SERVICE BULLETIN

Subject: TS45 STAIRS INSULATION
IMPROVEMENT

Bulletin Nu: TS45-FC-2201

This service bulletin describes the change of insulation set at the stair zone of the vehicle.

Figure.1. The disassembly of the front bumper

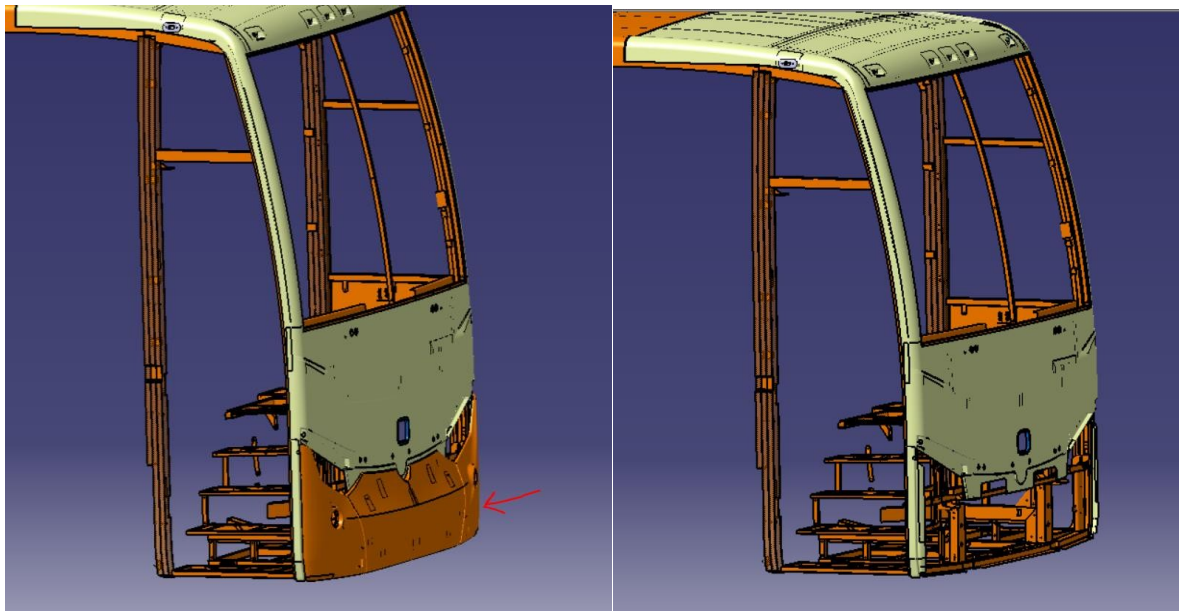
1. The front bumper of the vehicle must be disassembled (as shown in Figure.1) to reach the insulation zone which is shown in Figure.2.

Figure.2.The disassembly of the nail head

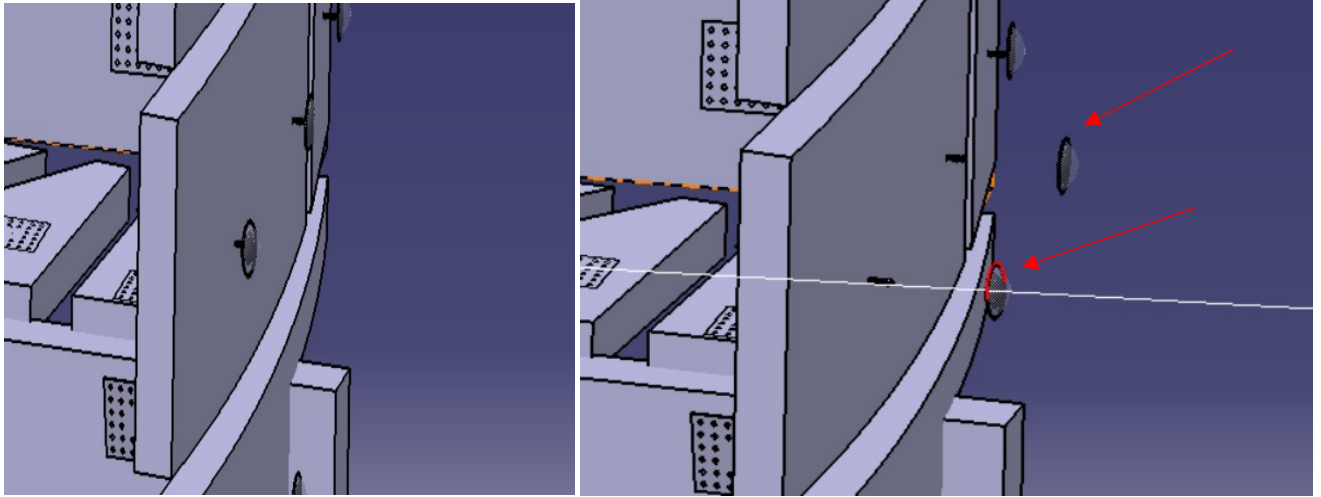
2. The nail head of the insulation must be disassembled to remove the insulations at the stairs of the vehicle.

Figure.3 Stairs insulation set of the vehicle

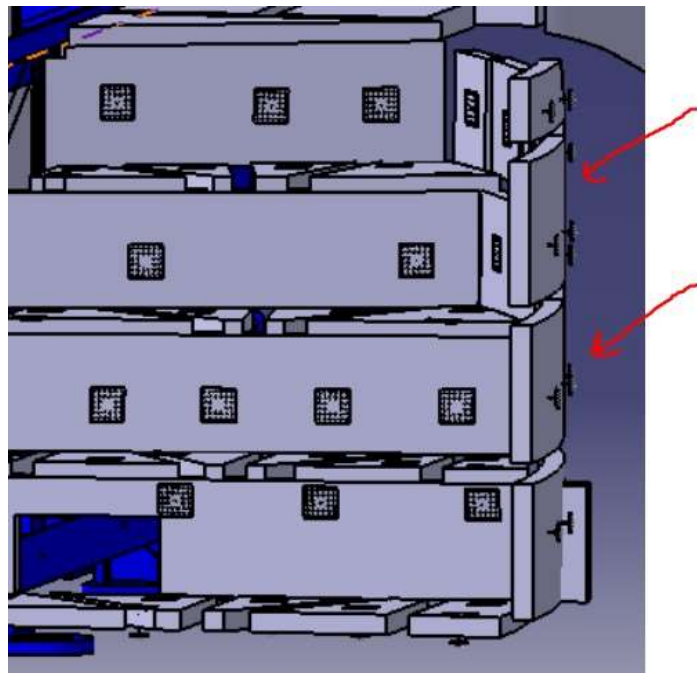
3. Then, the insulation which is shown in the following figure must be demounted.

The new insulations of the stairs can now be assembled to under and near of the stairs. The nail head of the insulations must be reassembled and the sealar must be carried out the edges of the insulations. Please note that, sealar can not be applied to the surface of the mounted insulations.
